Applicant : Martin Behringer et al.
Serial No. : 09/787,186
Filed : March 15, 2001
Page : 10 of 10

Amendments to the Drawings:

The attached replacement sheet of drawings includes changes to Figs. 1 and 2 and replaces the original sheet including Figs. 1 and 2.

FIGURE 1

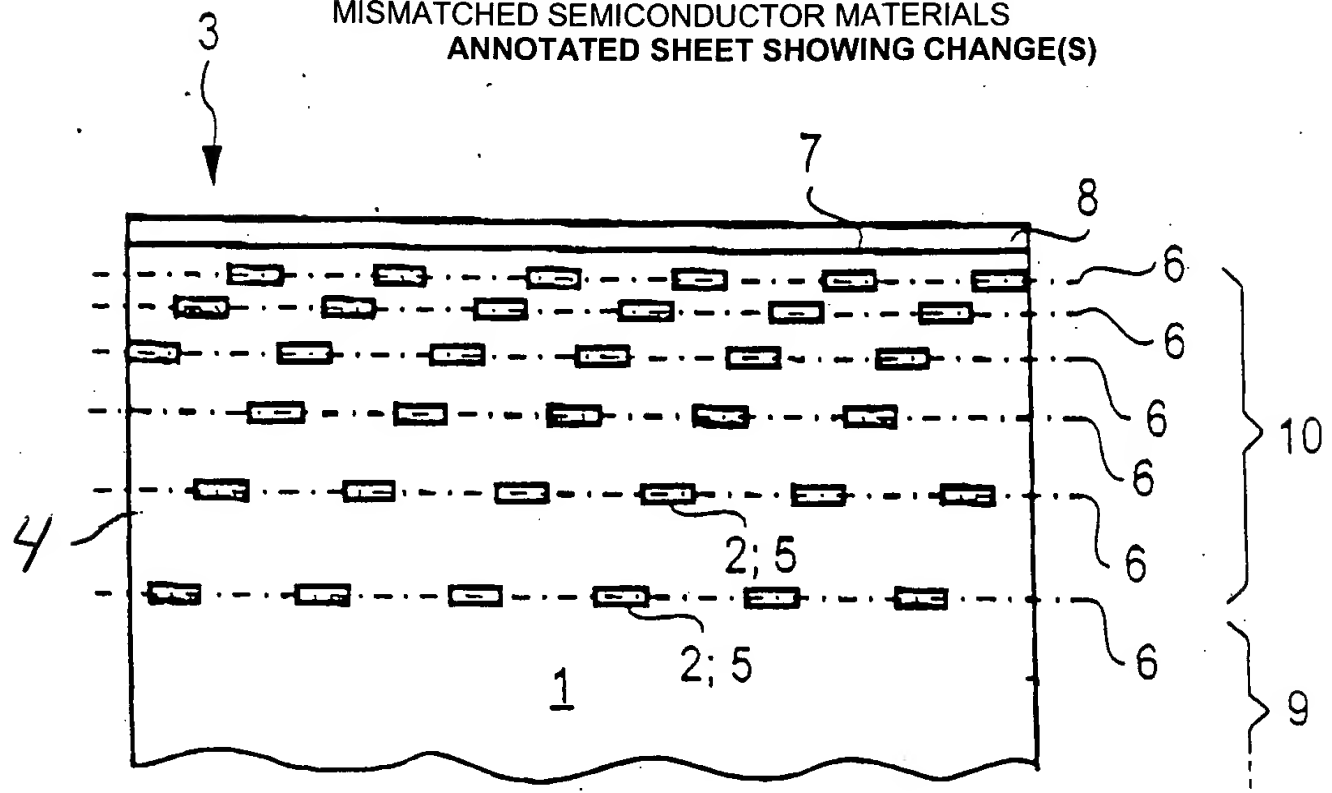
In Fig. 1, the reference numeral 4 has been amended to point into within layer 10 rather than layer 9. In Figs. 1 and 2, the terms "FIGURE 1" and "FIGURE 2" have been moved below each respective drawing. The attached Annotated Sheet Showing changes shows the additions in red.

FIGURE 2

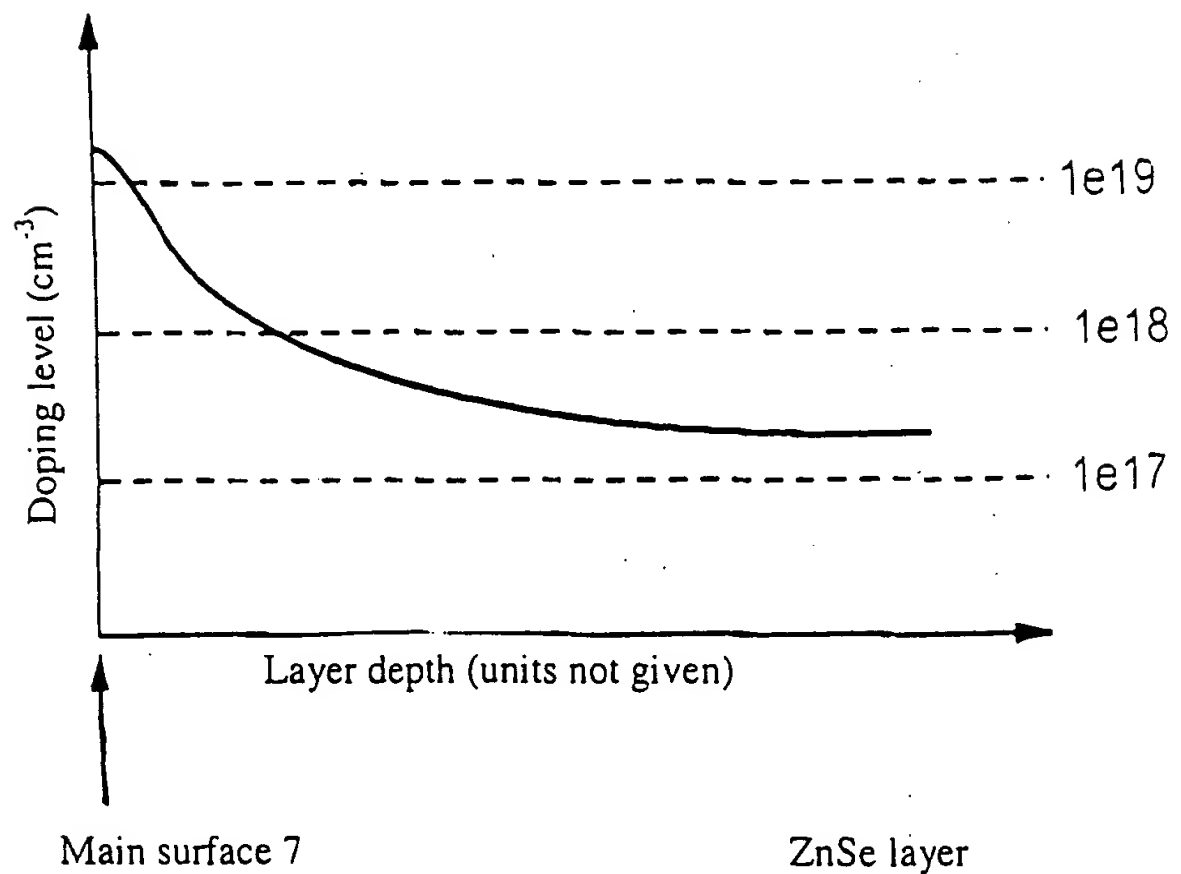
New claims 5-10 generally correspond to the set of six claims originally filed with the PCT application. New claim 11 recites "wherein a main surface of the semiconductor body has a doping level greater than 10^{19}cm^{-3} ," and is supported by the graph in Fig. 2 which shows the doping level increasing to greater than 10^{19}cm^{-3} at the main surface. New claims 12-19 correspond to various permutations of features in the prior claims.

With regard to the Section 112 rejection, and as described above, we note that the claim limitation "wherein a main surface of the semiconductor body has a doping level greater than 10^{19}cm^{-3} ," is supported by the graph in Fig. 2 which shows the doping level increasing to greater than 10^{19}cm^{-3} at the main surface.
